UNITED STATES PATENT AND TRADEMARK OFFICE

APPLICATION NO.	FILING DATE	FIRST NAMED INVENTOR	ATTORNEY DOCKET NO.	CONFIRMATION NO.
10/522,860	08/12/2005	Thierry Bernard	930092-2009	4878

Office Action Summary	Application No. 10/522,860	Applicant(s) BERNARD, THIERRY	
	Examiner Stewart T. Knox	Art Unit 3641

DETAILED ACTION

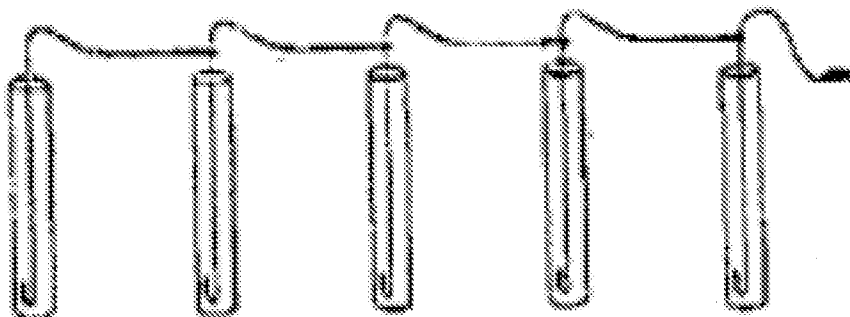
6. Claim 1 is rejected under 35 U.S.C. 103(a) as being obvious over Manual Tecnico and Denasa Detonantes (hereafter "Manual Tecnico"). Manual Tecnico shows the following arrangement:

7. The above arrangement comprises a pyrotechnical firing installing for use in a firing program, the firing installation comprising a plurality of detonators (at the bottom), each detonator provided with a cable comprising an end connector at the end of a terminal or end part of the cable, and a surface line to which the cable of each detonator is connected via the end connector, wherein the surface line is at least partially formed by successive sections of the electrical cables of the plurality of detonators, every section comprising the terminal or end part of one of the cables coming from one of the plurality of detonators and the end connector of the cable, thereby to connect the terminal or end part of one cable to the cable of the next detonator to define the origin of the next detonator's terminal or end part anywhere on the electrical cable of the next detonator. Manual Technico does not disclose that this arrangement is used with an electrical cable with electrical connections. It would have been obvious to one of ordinary skill in the art at the time the invention was made to modify the arrangement of Manual Technico to use electrical cables and connections, since electrical cables are well known in the art of detonators and such a modification would bring the advantages of Manual Technico's arrangement to a broader range of detonator types.

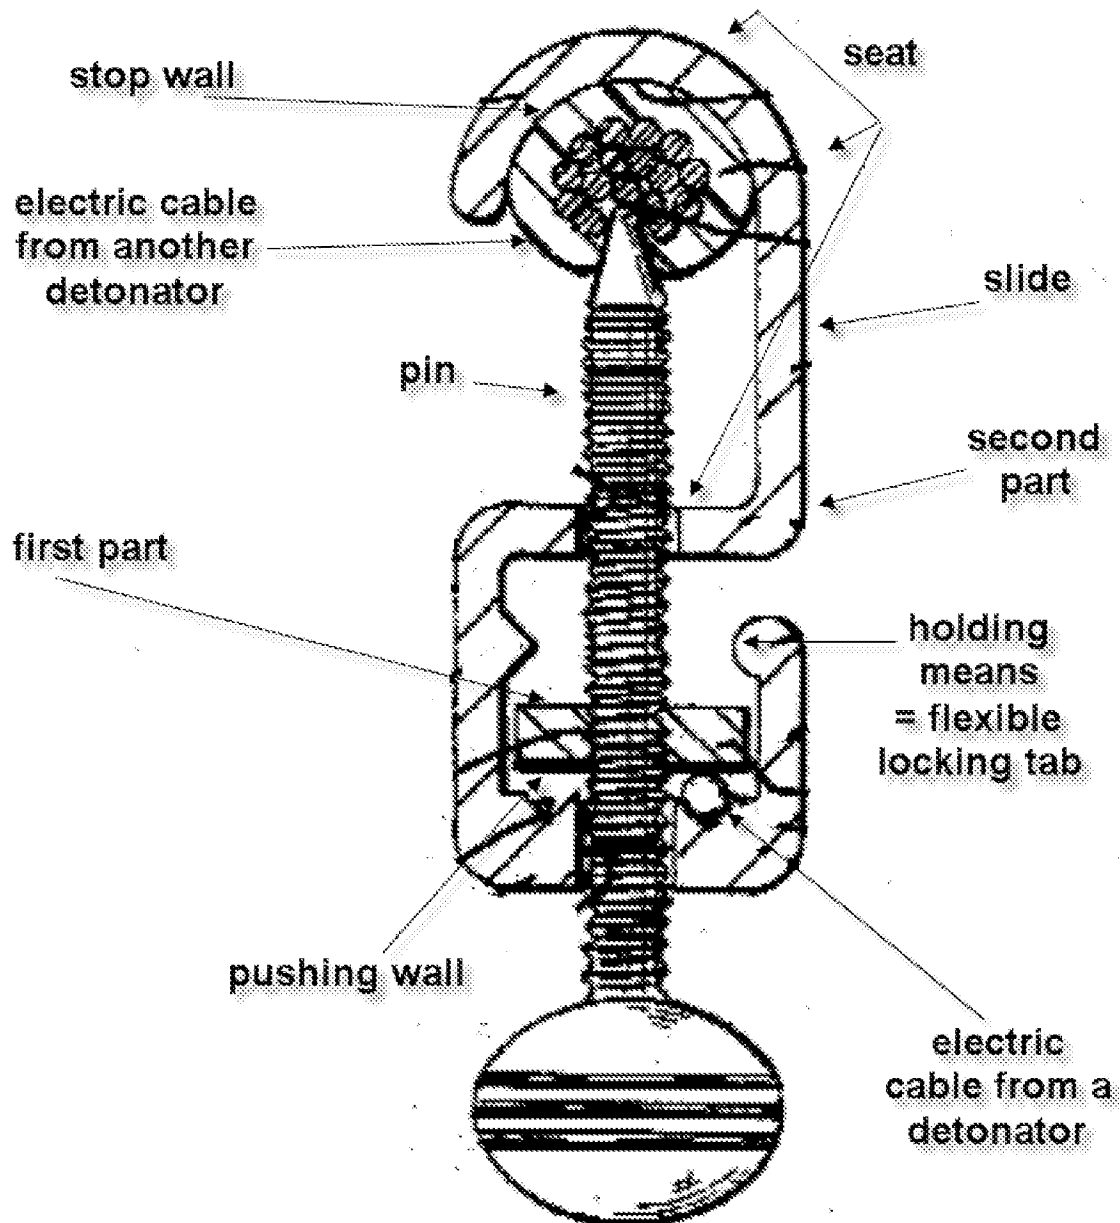
8. Claims 2-6 are rejected under 35 U.S.C. 103(a) as being unpatentable over Manual Technico as applied to claim 1 above, and further in view of Holtzapple (3,594,703). Manual Technico as applied above discloses the claimed invention, but does not disclose an end connector. Holtzapple discloses an end connector for use in a pyrotechnical firing installation, labeled in a diagram on the next page, containing the following elements:

9. a first part solid with the end of an electrical cable which electrical cable comes from a detonator, the first part provided laterally with a connection pin to penetrate, in use, into the inside of an electrical cable coming from another detonator, and on the opposite side to the pins a pushing wall, and

10. a second part comprising a slide and a stop wall, into which the first part is mounted movable in relation to the stop wall which faces the connection pins, the wall and the slide defining a seat suitable for receiving an electrical cable oriented transversely to the electrical cable equipped with the connector.

11. In regard to claim 3, Holtzapple discloses that the slide comprises lateral walls, perpendicular to the stop wall, of which at least one of the lateral walls comprises on its outside a holding means of the first part provided with a flexible locking tab approximately perpendicular to the pushing surface.

14. In regard to claim 6, the stop wall may be provided, opposite the slide, with a lateral wedging bead for the electrical cable received in the seat (figures 6 and 8, element 128).
